REPORT TO CITY PLAN COMMISSION

Item: Preliminary Plat/ Aspen Meadow

Aspen Meadow Subdivision Preliminary Plat

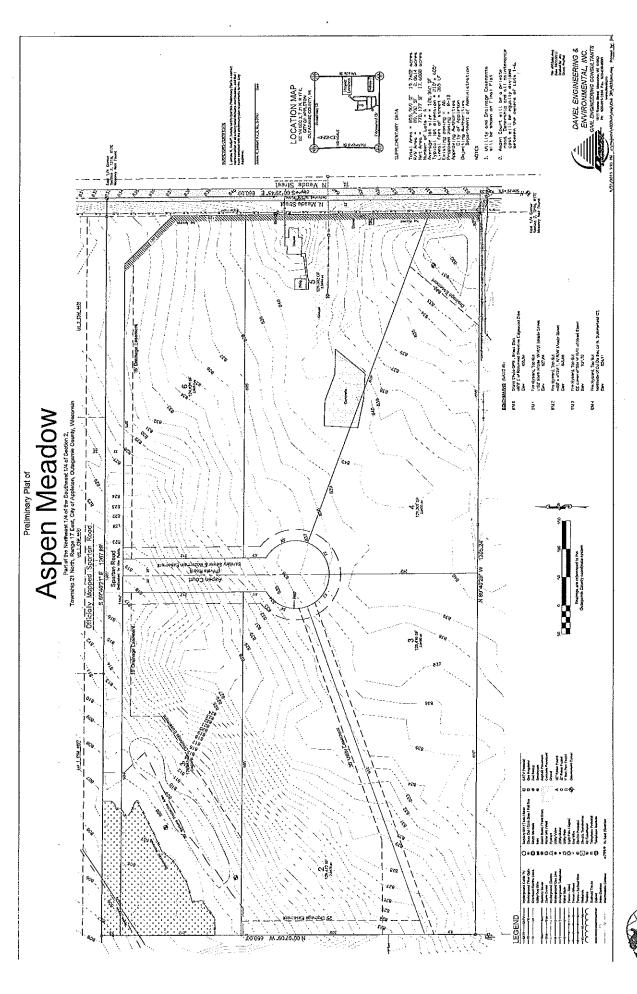
- 1. Rezoning of the property to R-1A Single-family residential must be approved by the Common Council prior to City signatures being affixed to the final plat.
- 2. The location of Officially Mapped Spartan Drive shall be revised to the correct location prior to approval of the final plat.
- 3. All stormwater management requirements must be met.
- 4. Park fees of \$300 per lot are due prior to the City signing the final plat.
- 5. The existing house shall be removed prior to a new single-family dwelling being constructed on Lot 5.
- 6. 17-17 (b)(4) Identify the location of abutting lot lines and names of any adjacent subdivisions, parks, cemeteries and unplatted lands.
- 7. 17-17 (b)(9) Identify corporate limit lines within the exterior boundaries of the plat or immediately adjacent thereto.
- 8. 17-17 (b)(6) and (11) All elevations shall be based on City datum.
